EPC Stormwater

Re: *Ellicott School Addition 2 bldgs*
Project No. 61183
PCD File No. PPR2250

Final Drainage Report Comments Response

PHASE I - PBMP
TRIBUTARY
MAP

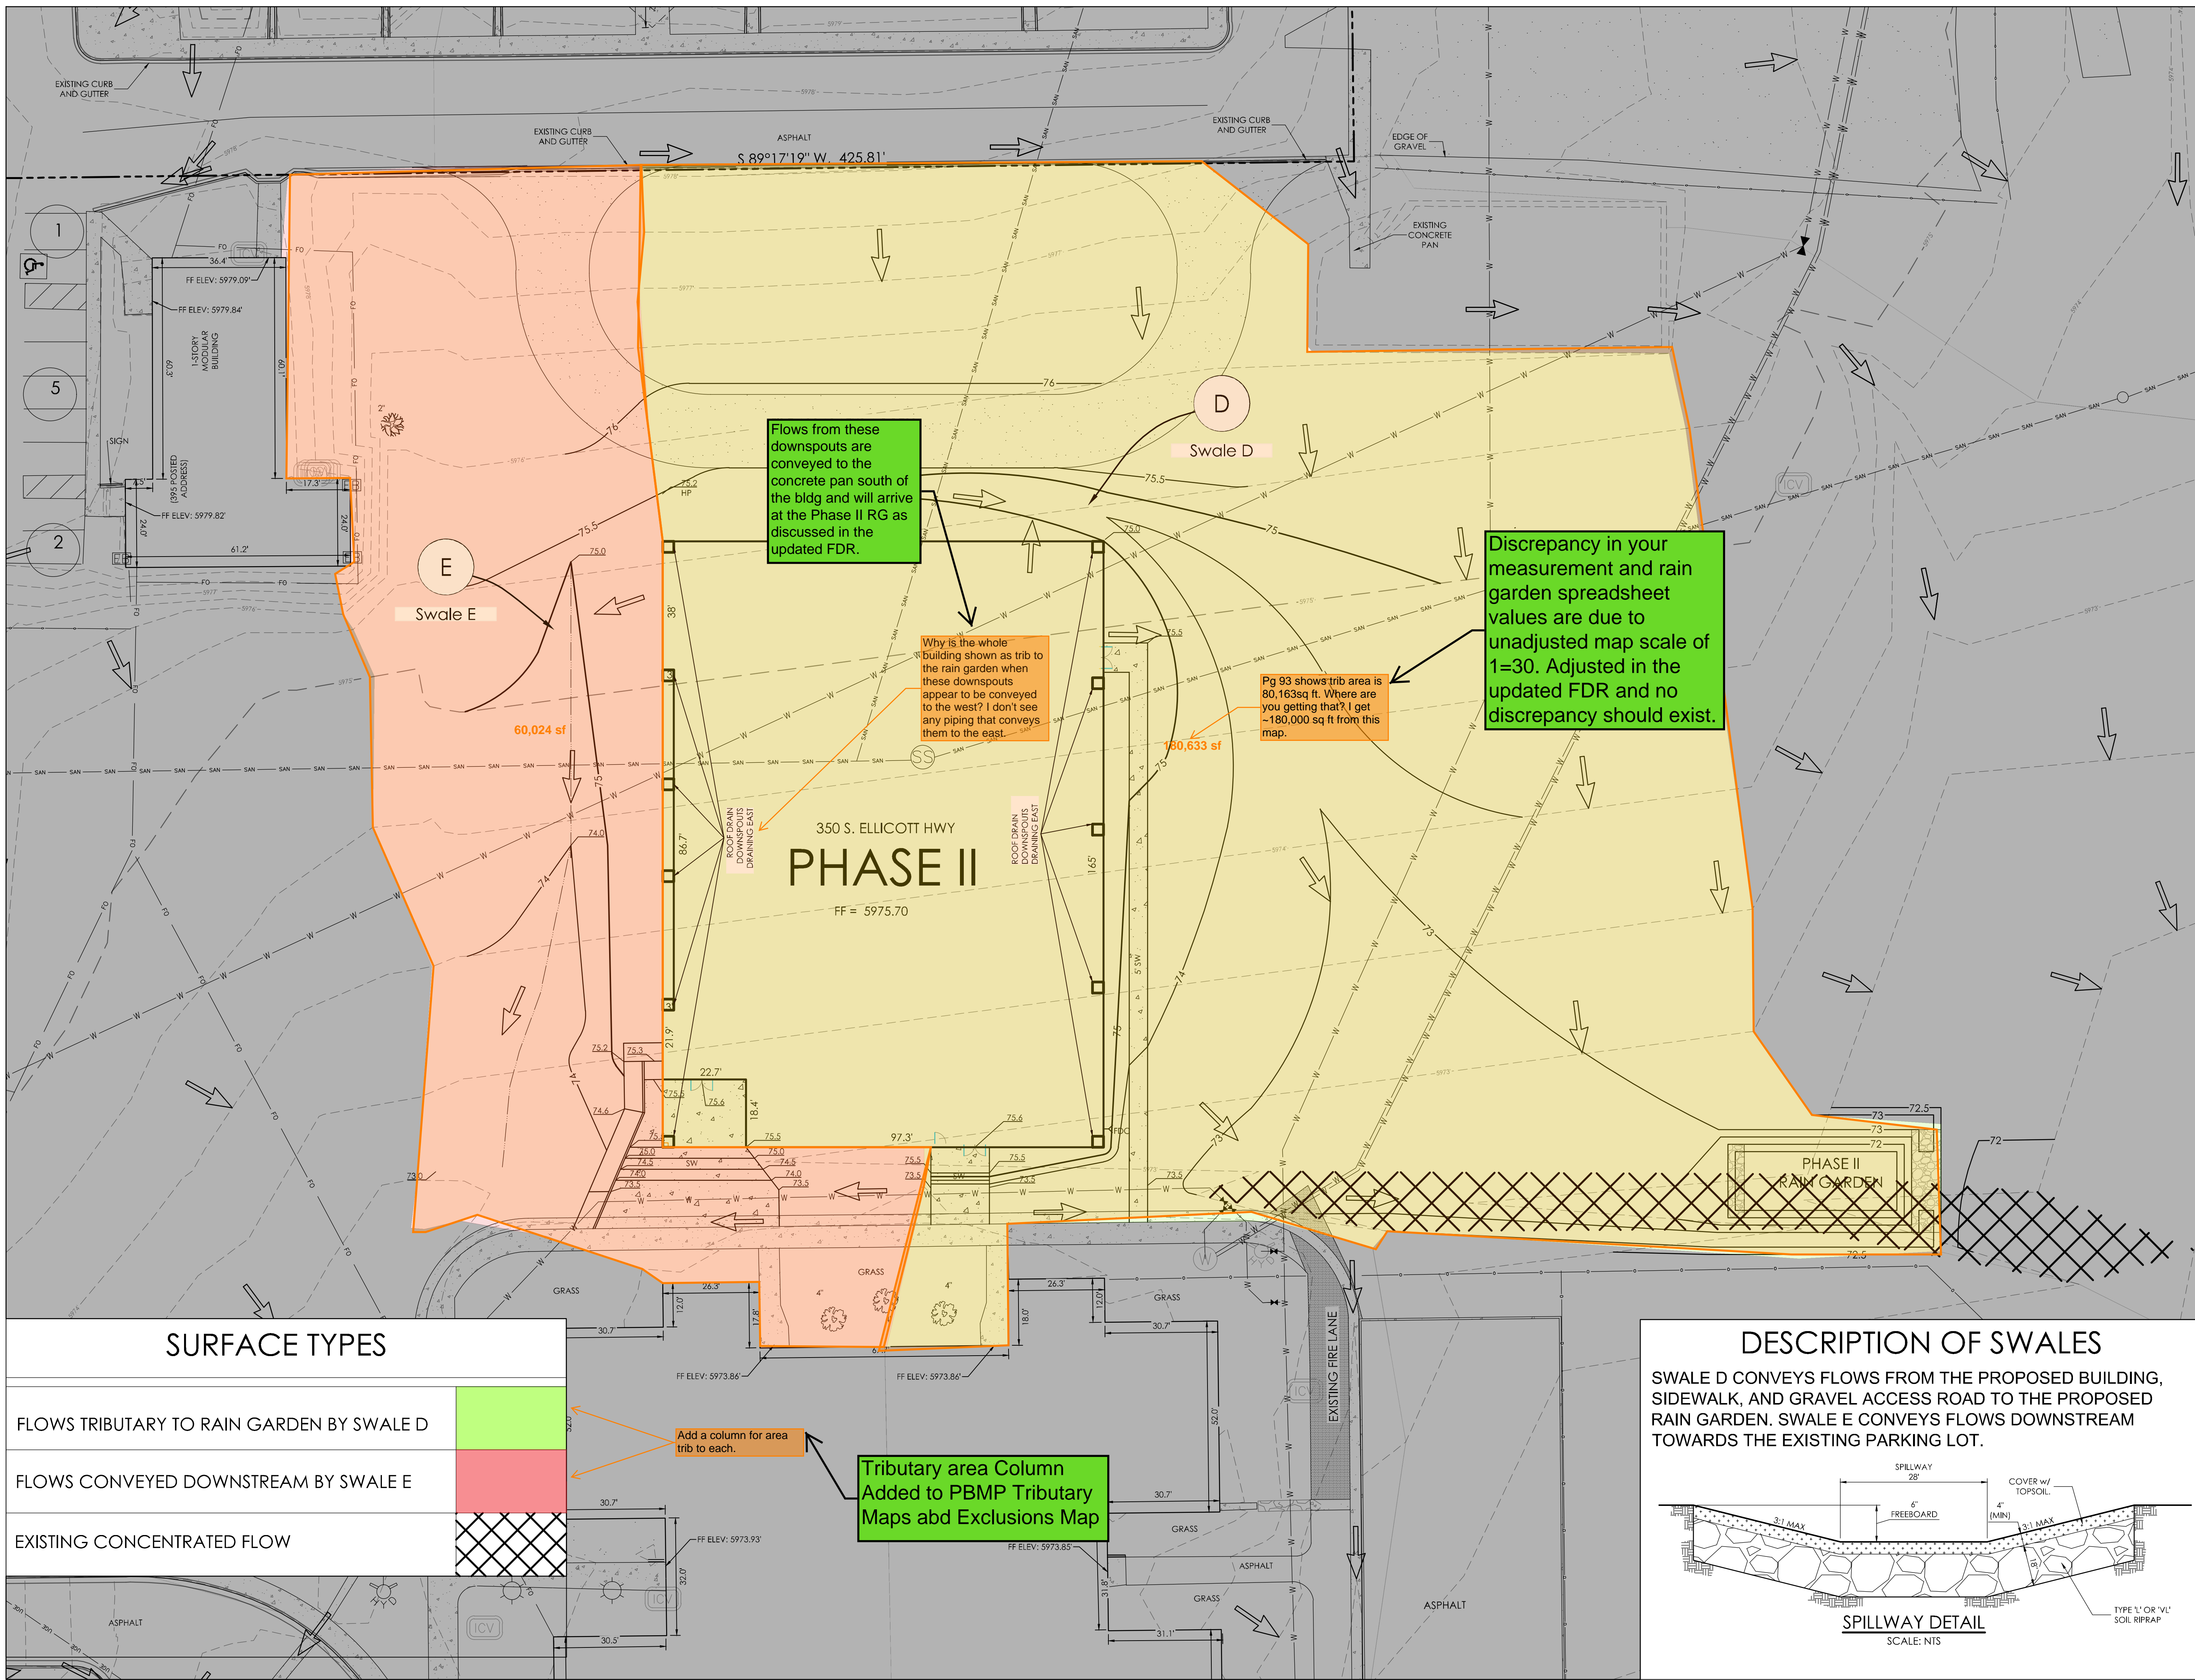
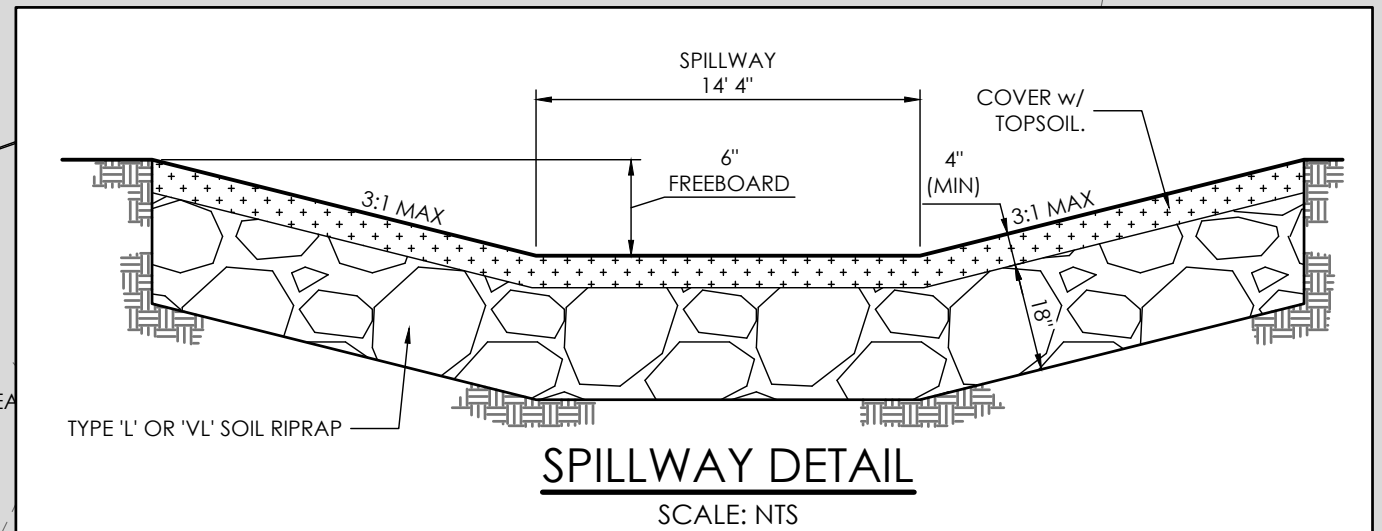
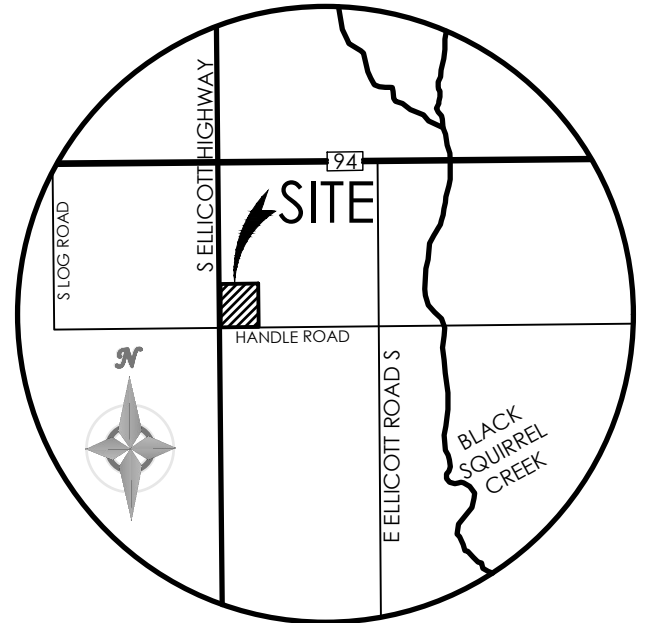
Pg 91 shows trib area is 27,171sq ft. Where are you getting that? I only get ~7,000 sq ft from this map. Although, oversizing the pond is acceptable.

How is flow from this downspout conveyed to the rain garden? Surface flow from there will not convey flows to the swale south of the bldg and into the RG.

Add a column for area trib to each.

Discrepancy in your measurement and rain garden spreadsheet values are due to unadjusted map scale of 1=10. Adjusted in the updated FDR and no discrepancy should exist.

Flows from this downspout are conveyed to the swale south of the bldg and will arrive at the Phase I RG

Tributary area Column Added to PBMP Tributary Maps and Exclusions Map

LANDSCAPING PLAN PHASE I & II

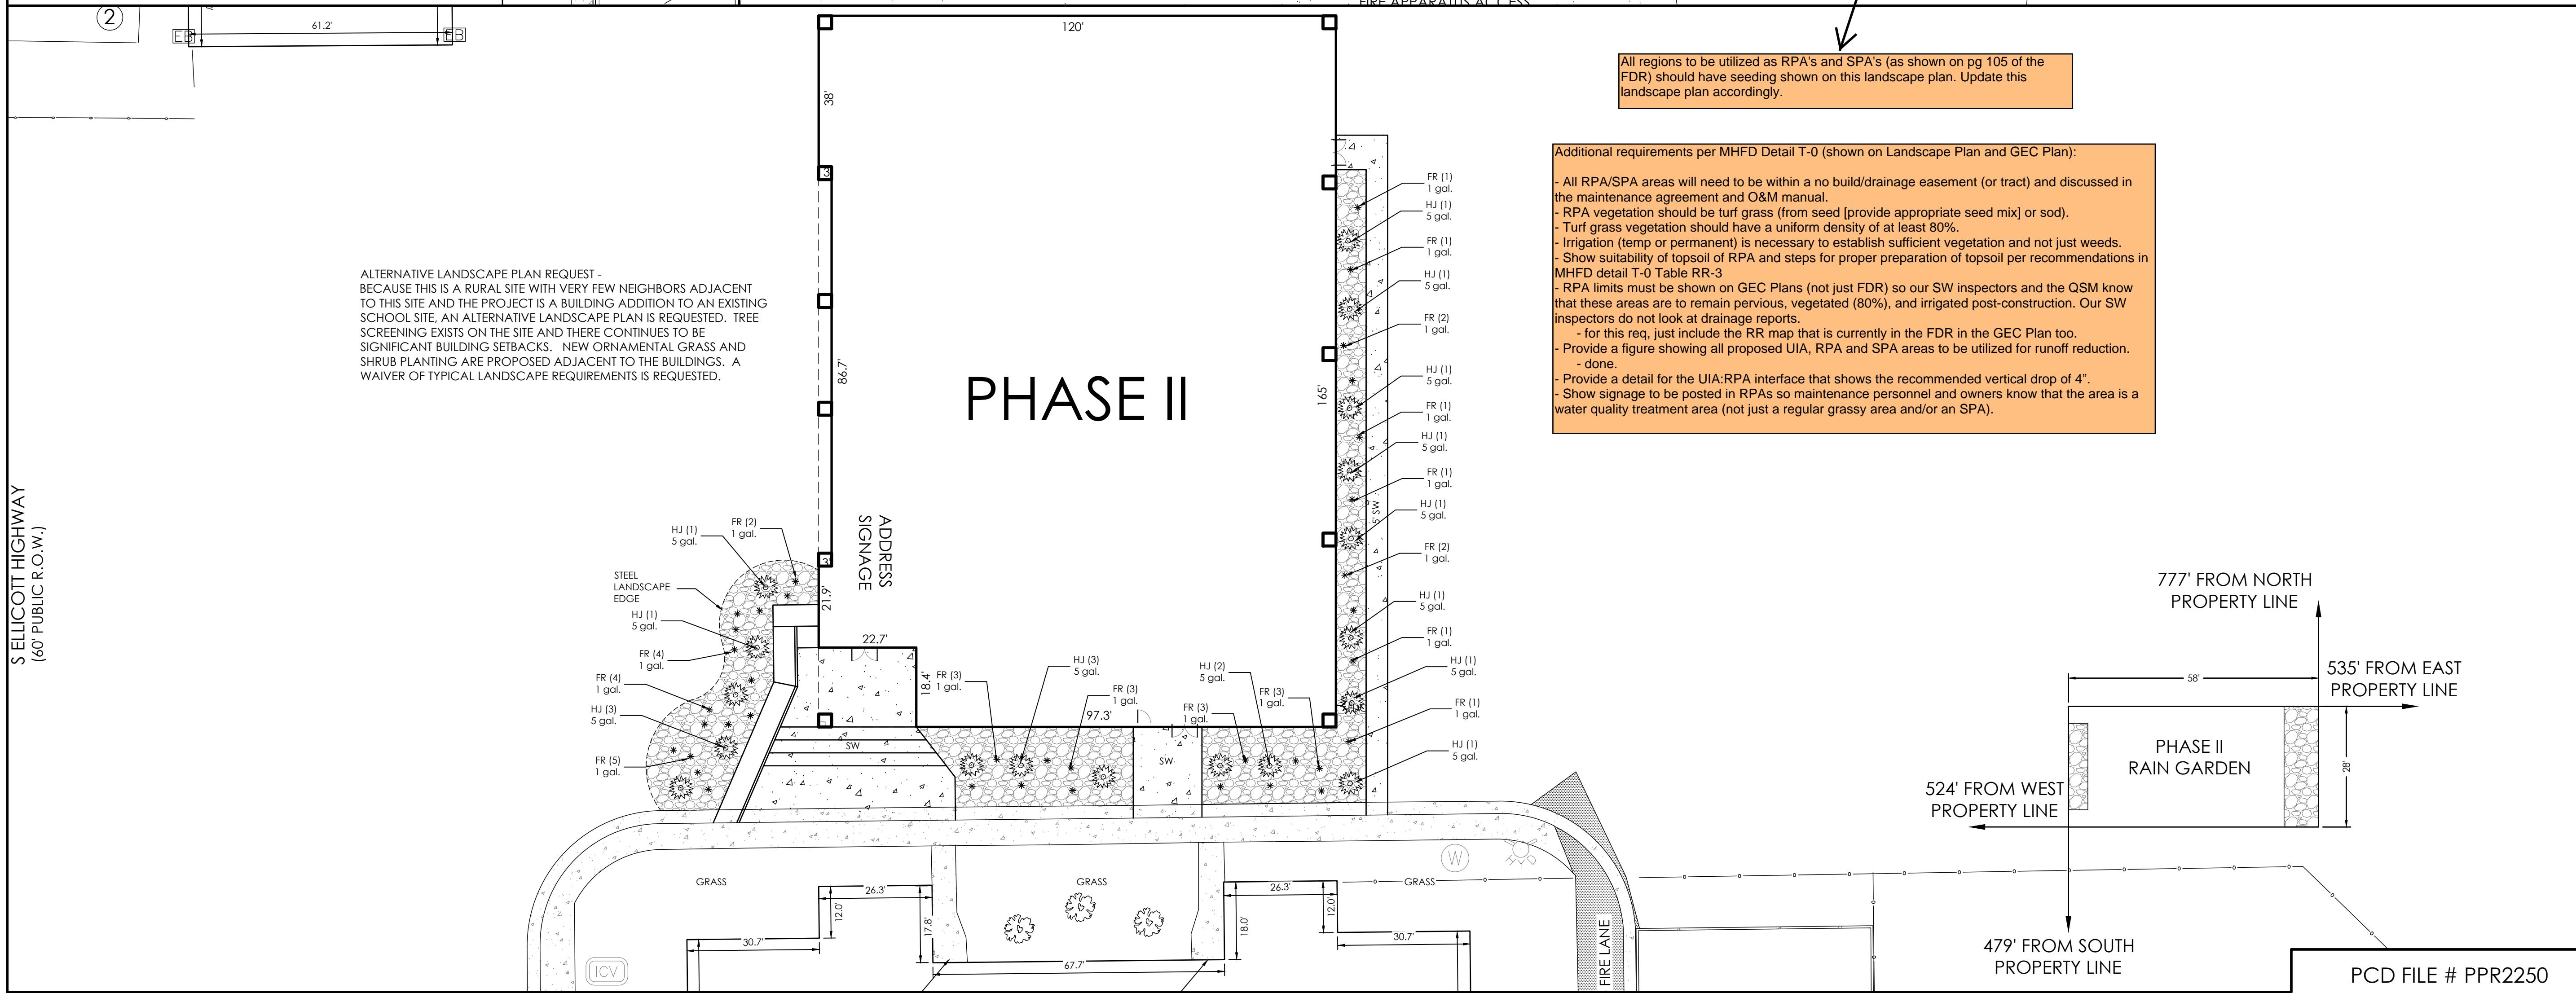
All regions to be utilized as RPA's and SPA's (as shown on pg 105 of the FDR) should have seeding shown on this landscape plan. Update this landscape plan accordingly.

Additional requirements per MHFD Detail T-0 (shown on Landscape Plan and GEC Plan):

- All RPA/SPA areas will need to be within a no build/drainage easement (or tract) and discussed in the maintenance agreement and O&M manual.
- RPA vegetation should be turf grass (from seed [provide appropriate seed mix] or sod).

- Turf grass vegetation should have a uniform density of at least 80%.
- Irrigation (temp or permanent) is necessary to establish sufficient vegetation and not just weeds.

- Show suitability of topsoil of RPA and steps for proper preparation of topsoil per recommendations in MHFD detail T-0 Table RR-3
- RPA limits must be shown on GEC Plans (not just FDR) so our SW inspectors and the QSM know that these areas are to remain pervious, vegetated (80%), and irrigated post-construction. Our SW inspectors do not look at drainage reports.

- for this req, just include the RR map that is currently in the FDR in the GEC Plan too.
- Provide a figure showing all proposed UIA, RPA and SPA areas to be utilized for runoff reduction.

- done.
- Provide a detail for the UIA/RPA interface that shows the recommended vertical drop of 4".
- Show signage to be posted in RPAs so maintenance personnel and owners know that the area is a water quality treatment area (not just a regular grassy area and/or a SPA).
